Product/Process Change Notice

Application or type : The 0201 packaging change.

Detail of the change : The bottom PAD product design changes.

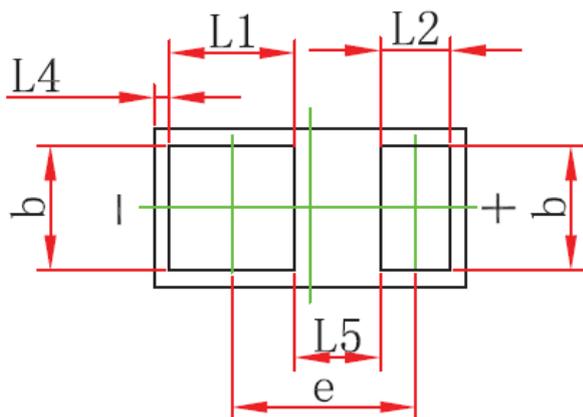
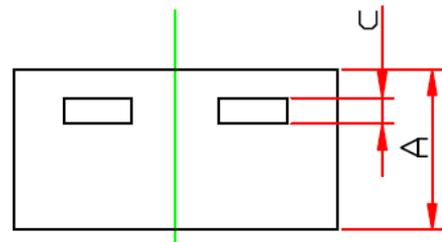
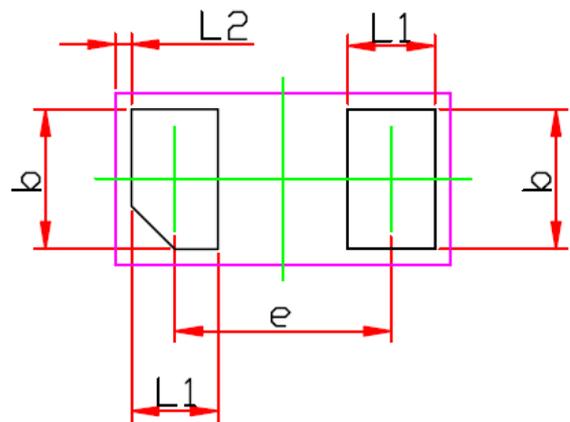
Reason for the change : 1. Change bottom PAD effectively improve process yield.												
Evaluation items : 1. Part No. affected:

DFNWB0.6×0.3-2L(P0.40T0.31) Outline Drawing

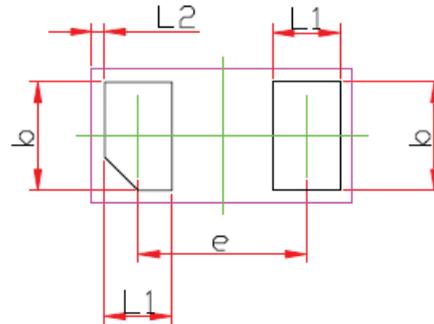
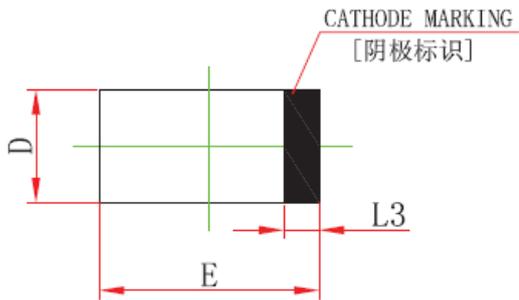
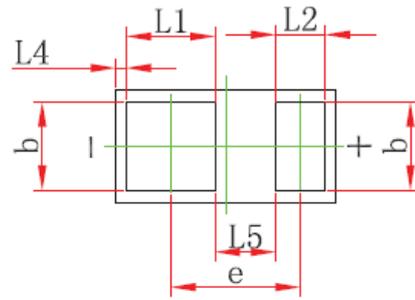
Product design (Appendix I)

After the change

Before the change
